CITY OF ALBUQUERQUE

Planning Department
Brennon Williams, Director

Re: **DEL TACO**
1500 Gibson Blvd SE
Traffic Circulation Layout
Architect's Stamp 10-12-2021 (L15-D049)

ENLARGED SITE PLAN
1"=20'-0"

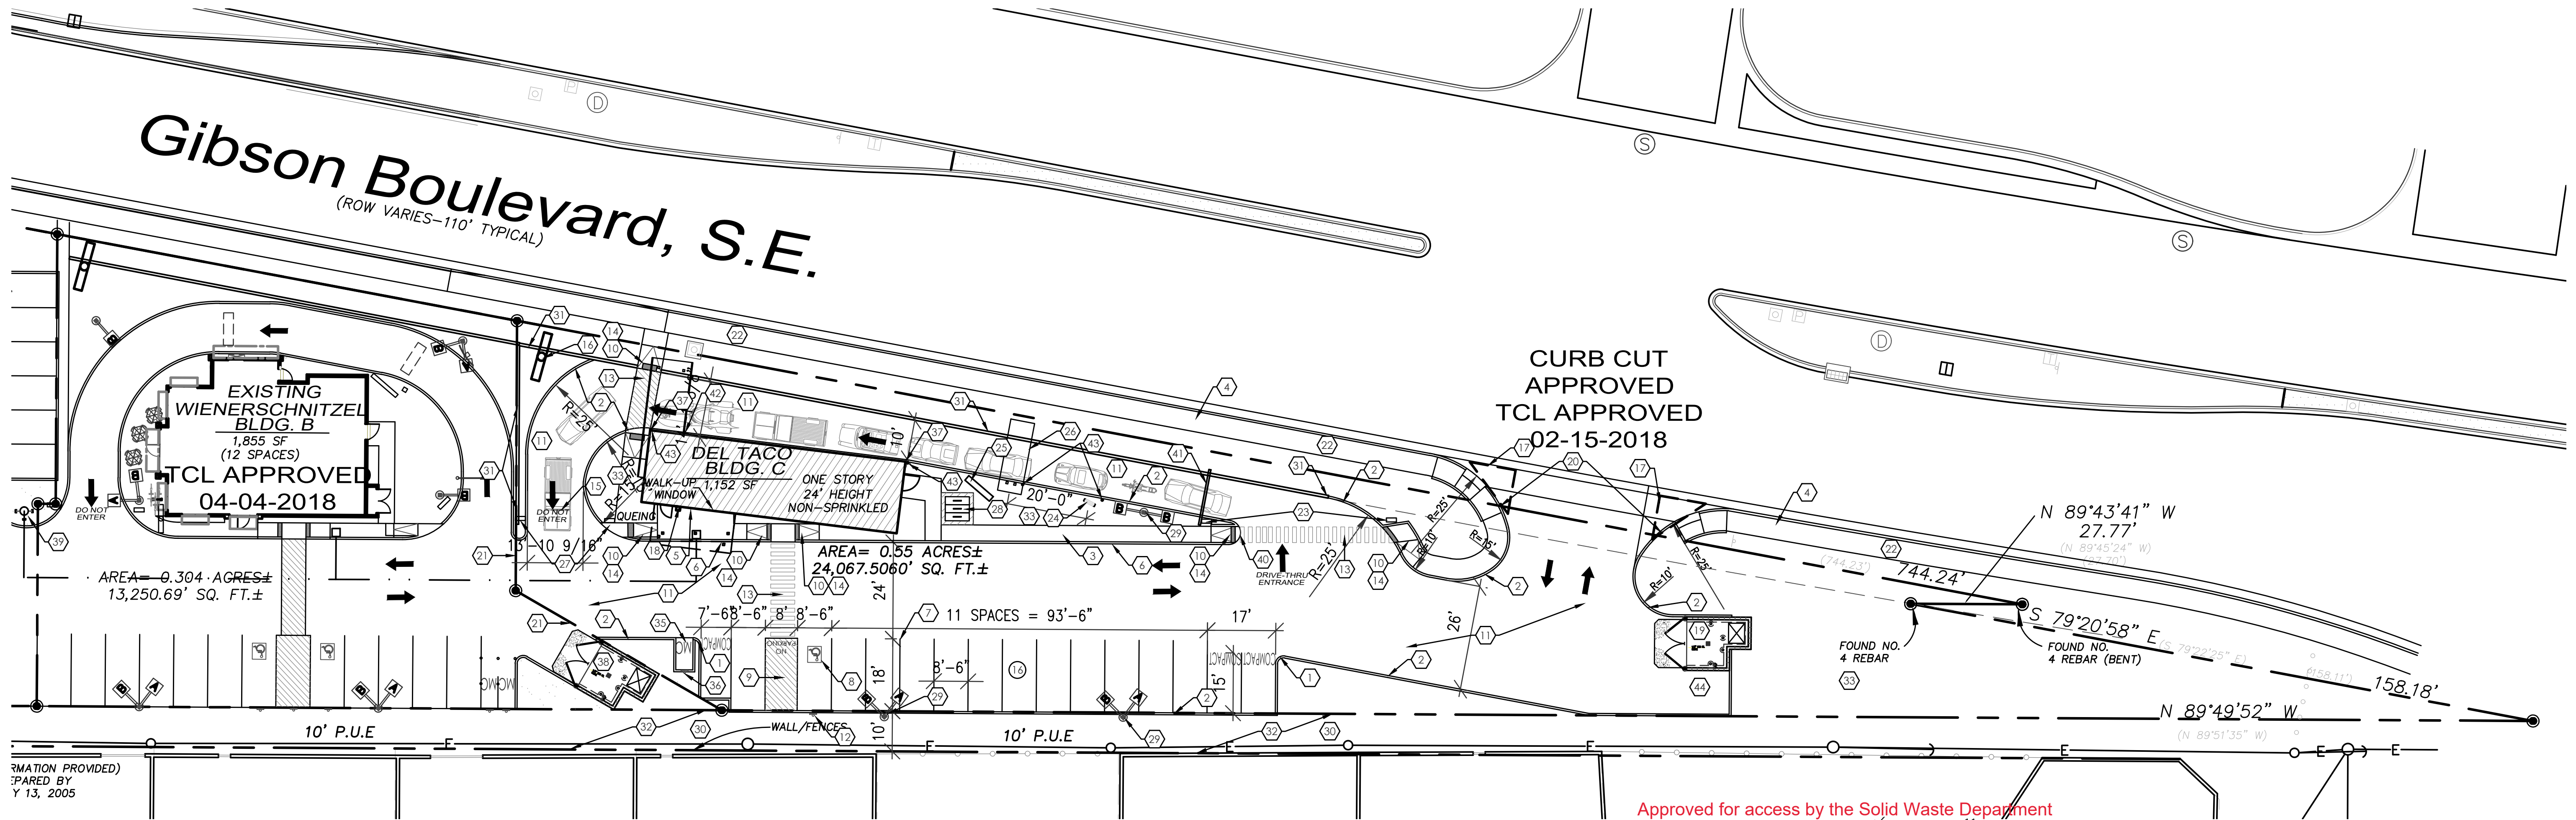
1. Provide existing and proposed sidewalk width.
2. All proposed pavement markings will need to have details provide
3. Keyed Note 2: Provide the size of proposed c&g (6") since there are several on COA std dwg 2415A.

4. Keyed Note 10 Accessible Ramp: Recommended referencing COA std dwg 2444, especially for the accessible ramps in front of the building entrance.
5. Keyed Note 27 & 36: provide signage's face details.

6. Keyed Note 16: please add not (proposed sign will need to be located on private property which includes air space.
7. Identify all existing access easements and rights of way width dimensions (If applicable).

8. ADA curb ramps must be updated to current standards and have truncated domes installed. Verify that existing Gibson Blvd. driveway entrance ramps are in compliance

9. Provide dimension for Motorcycle parking space.
10. List radii for all curves shown; for passenger vehicles (minimum radius per DPM 15 ft). Radius for delivery trucks, fire trucks, etc. is 25 ft. or larger.

11. Per the IDO, a 6 ft. wide ADA accessible pedestrian pathway is required from the public sidewalk to the building entrances. Please clearly show this pathway and provide details.

12. Per DPM, a 6 ft. wide ADA accessible pedestrian pathway is required from the ADA parking stall access aisles to the building entrances. Please clearly show this pathway and provide details.

13. ADA accessible pedestrian pathway should not be placed behind parking space or adjacent to a vehicular way. Vehicle and pedestrian/wheel chair conflicts should be avoided as much as possible. This is concerning the ADA parking stall access aisle across the main circulation drive aisle

14. Parking areas shall have barriers to prevent vehicles from extending over public sidewalk, public right-of-way, or landscaping.
15. ADA parking stall signage and 2 ft overhang is in conflict. Please clear up.

16. Provide details for "Do Not Enter" signage.
17. **The minimum drive through lane width is 12 feet with a 25 foot minimum radius (inside edge) for all turns. (A 15 foot radius can be used with an increase in lane width to 14 feet). Please dimension all lane widths and radii.**

18. Please provide a sight distance line (SSD) exhibit.
19. Please specify the City Standard Drawing Number when applicable.
20. Shared Site access: driveways that straddle property lines, or are entirely on one property but are to be used by another property, shall have an access easement. Please include a copy of your shared access agreement with the adjacent property owner.

21. Add a note stating "All broken or cracked sidewalk must be replaced with sidewalk and curb & gutter." A build note must be provided referring to the appropriate City Standard drawing (2430 & 2415A). This is the correct note and should be replaced on keyed note 22.

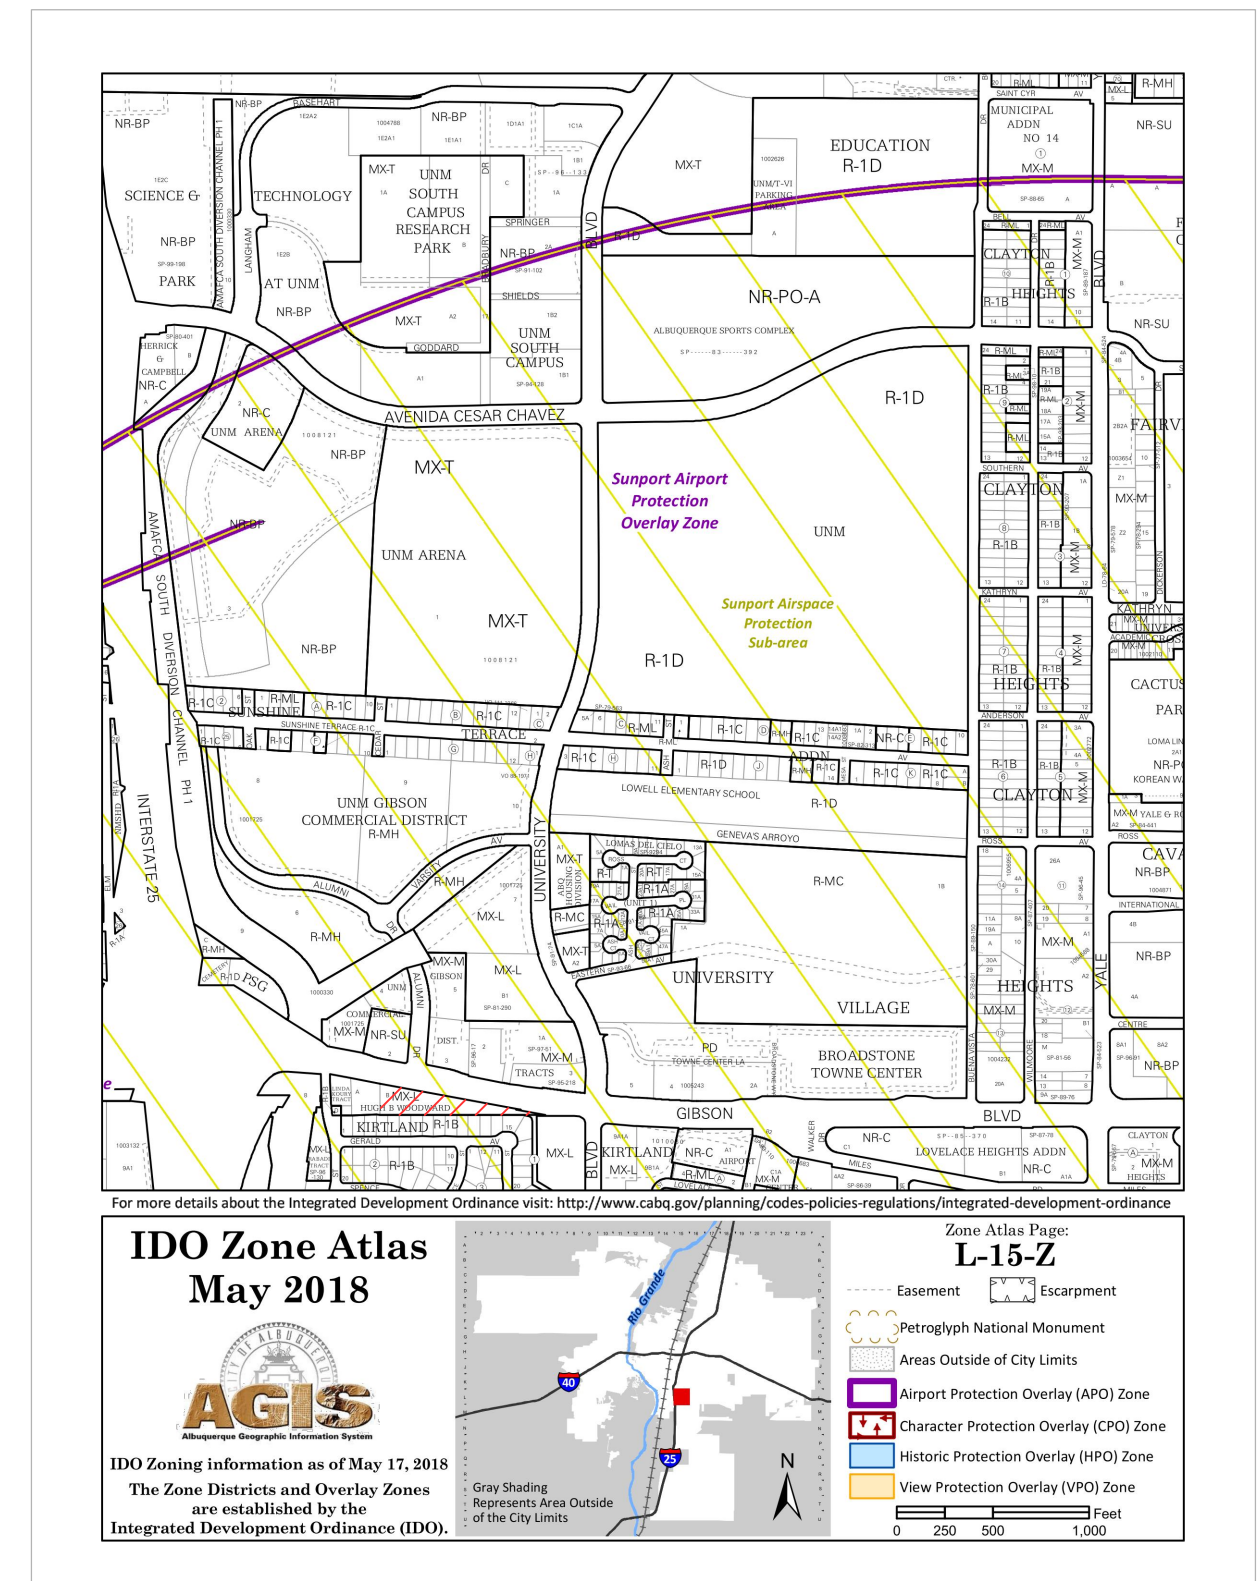
Approved for access by the Solid Waste Department
Herman Gallegos 10-19-21 *Herman Gallegos*
Hazard RouteNot approved for location of grease container**
